Platt Technical High School

ADDENDUM NO. 4

August 9, 2019

2 CHILLER PIPING DIAGRAM
SCALE: N.T.S.

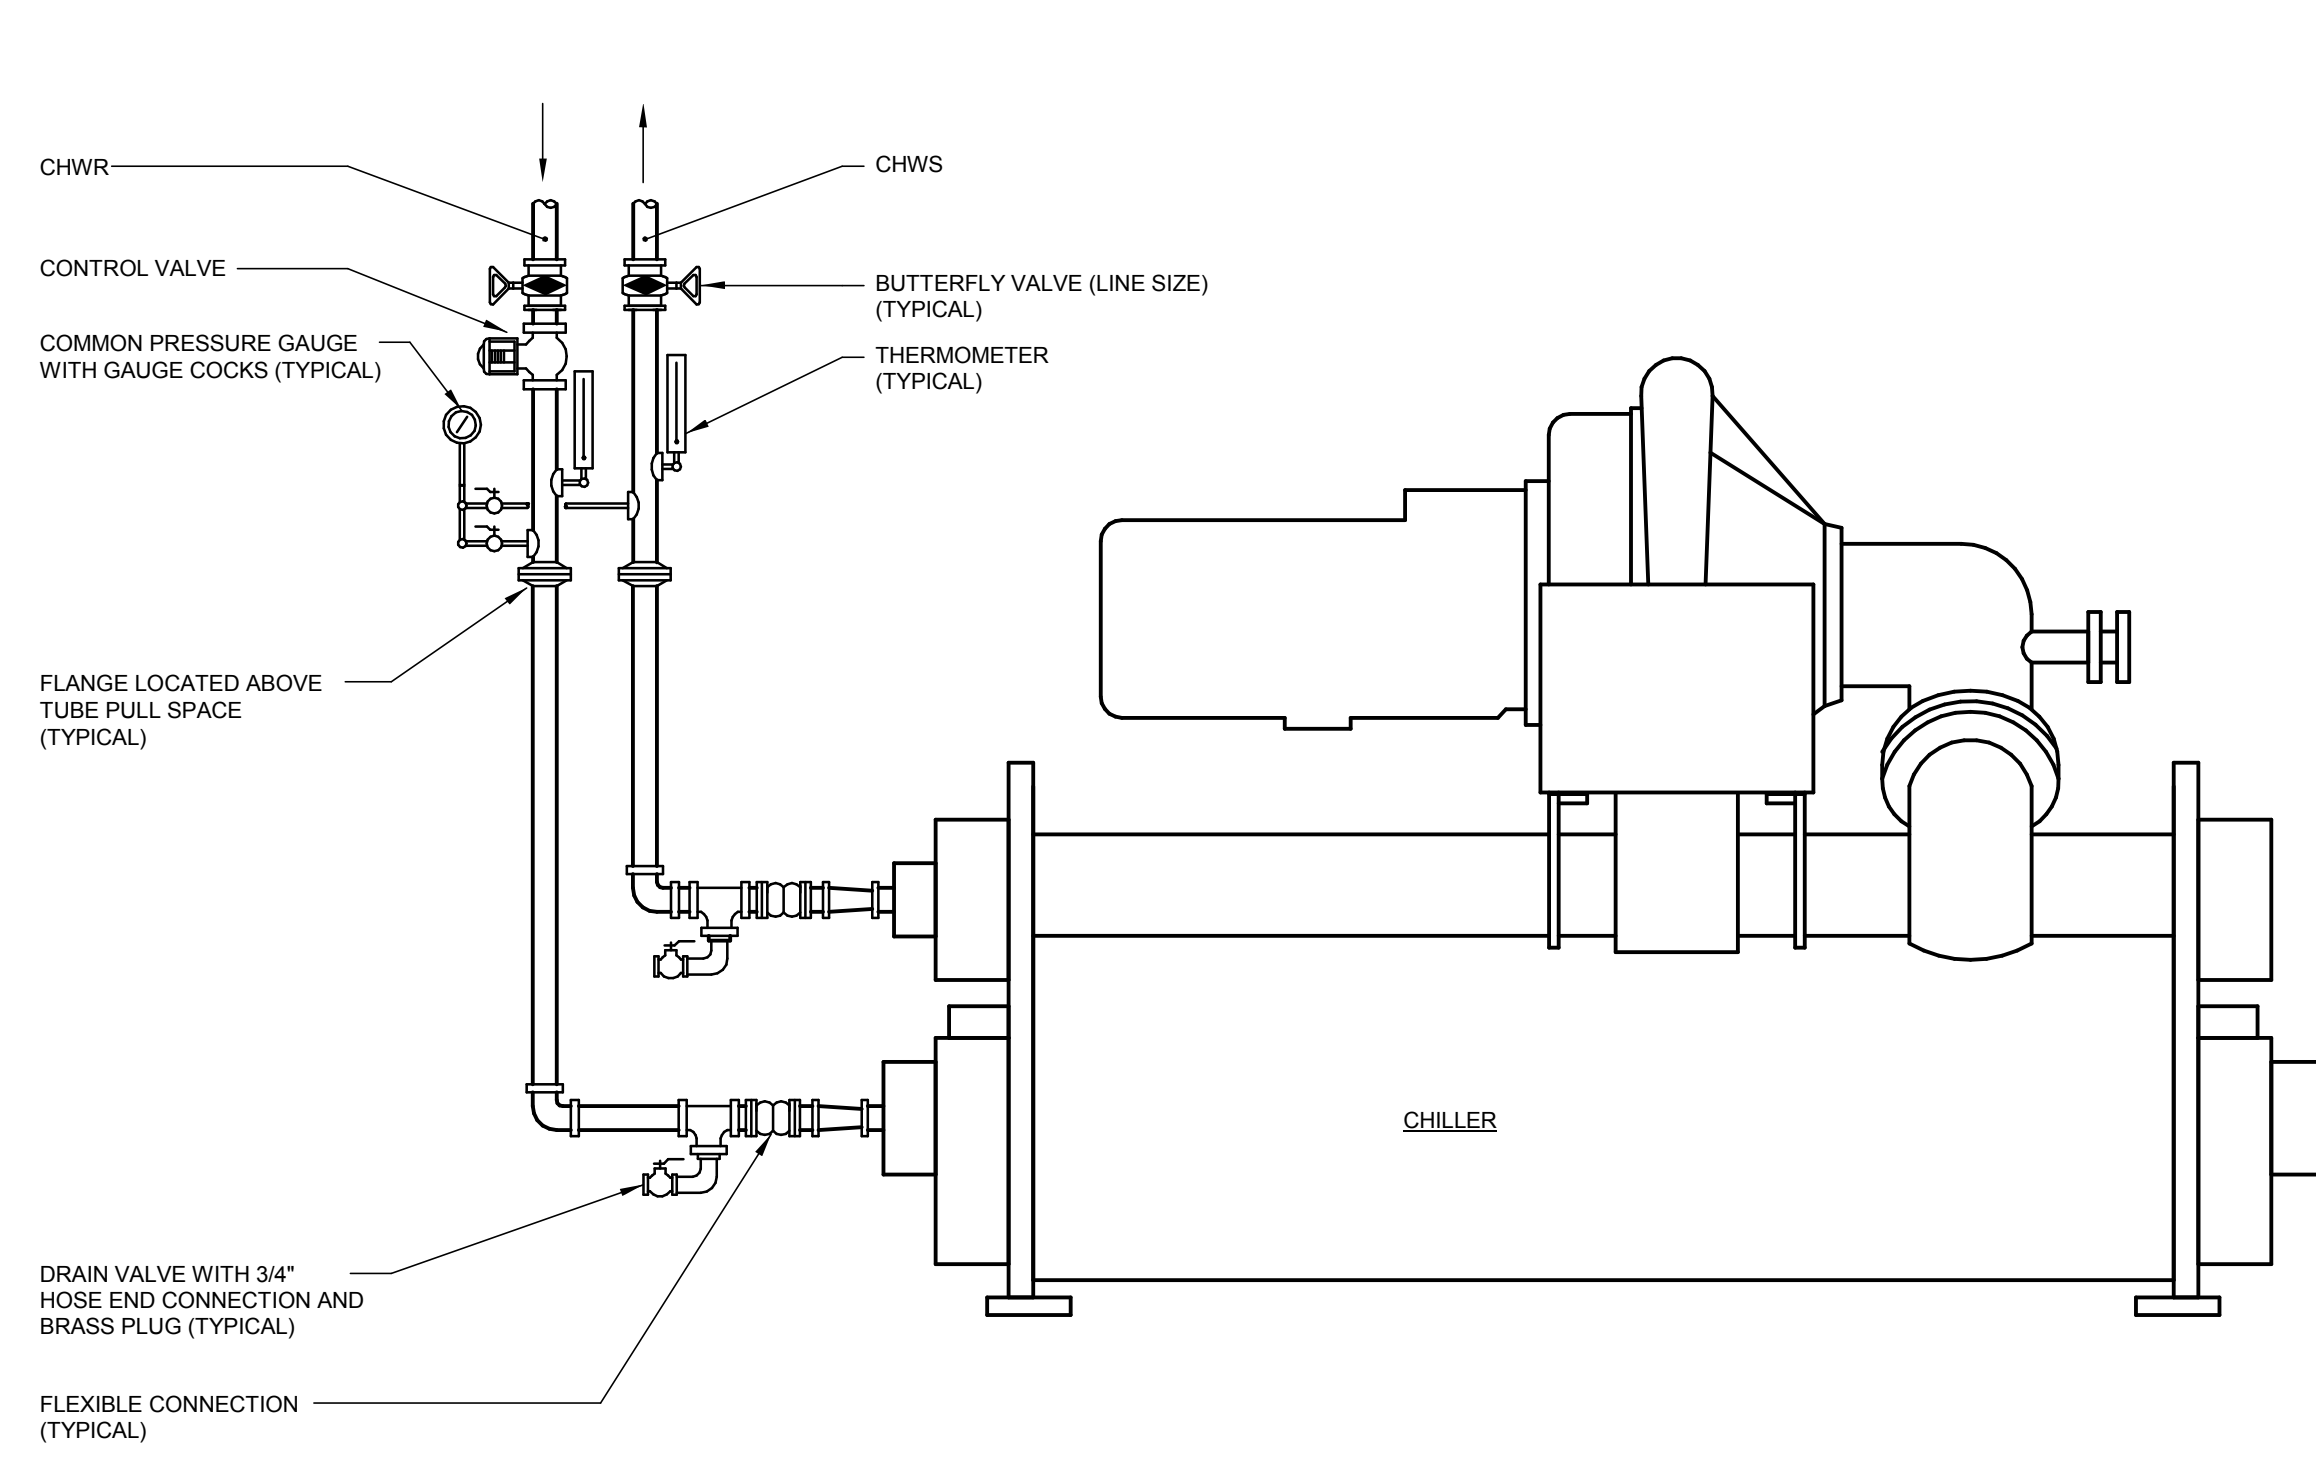
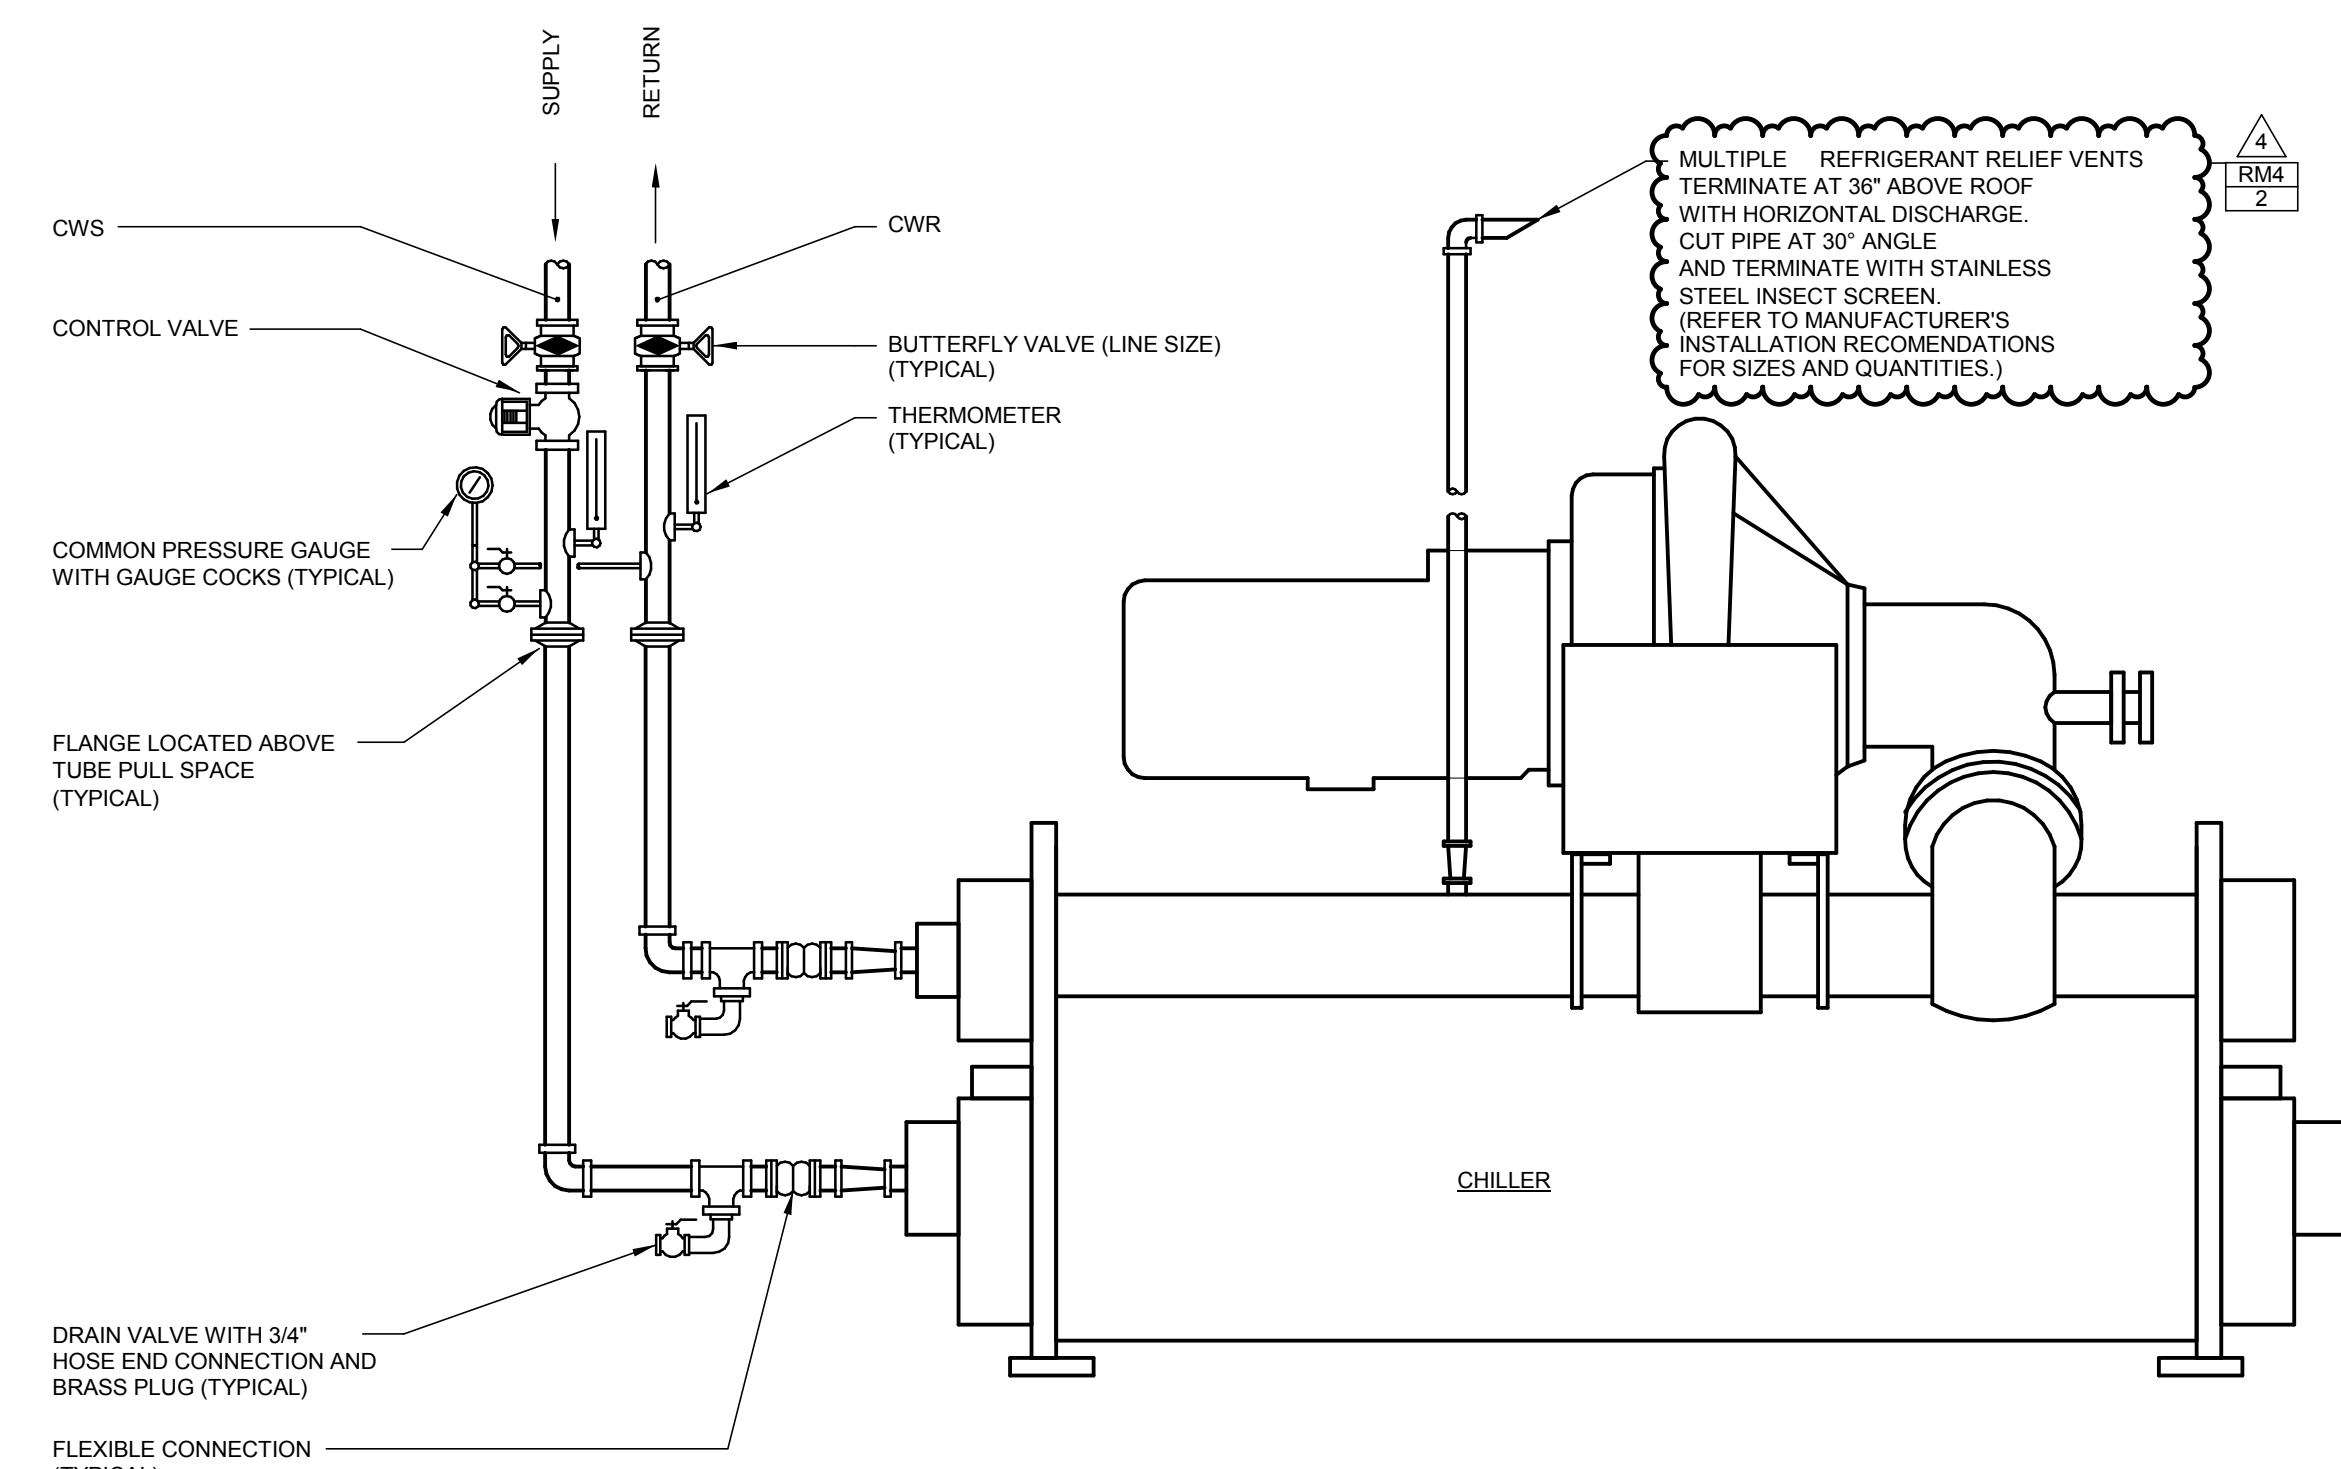
- ADD 4-142 DRAWING M2-1-1A – FIRST FLOOR MECHANICAL PIPING PLAN AREA A**
Updated condensate drain piping serving FCU's and CAC-3 per Revision RM4-1.
- ADD 4-143 DRAWING M4-1-3 – MECHANICAL DETAILS**
Revise Detail #2 regarding chiller relief vent piping per Revision RM4-2.
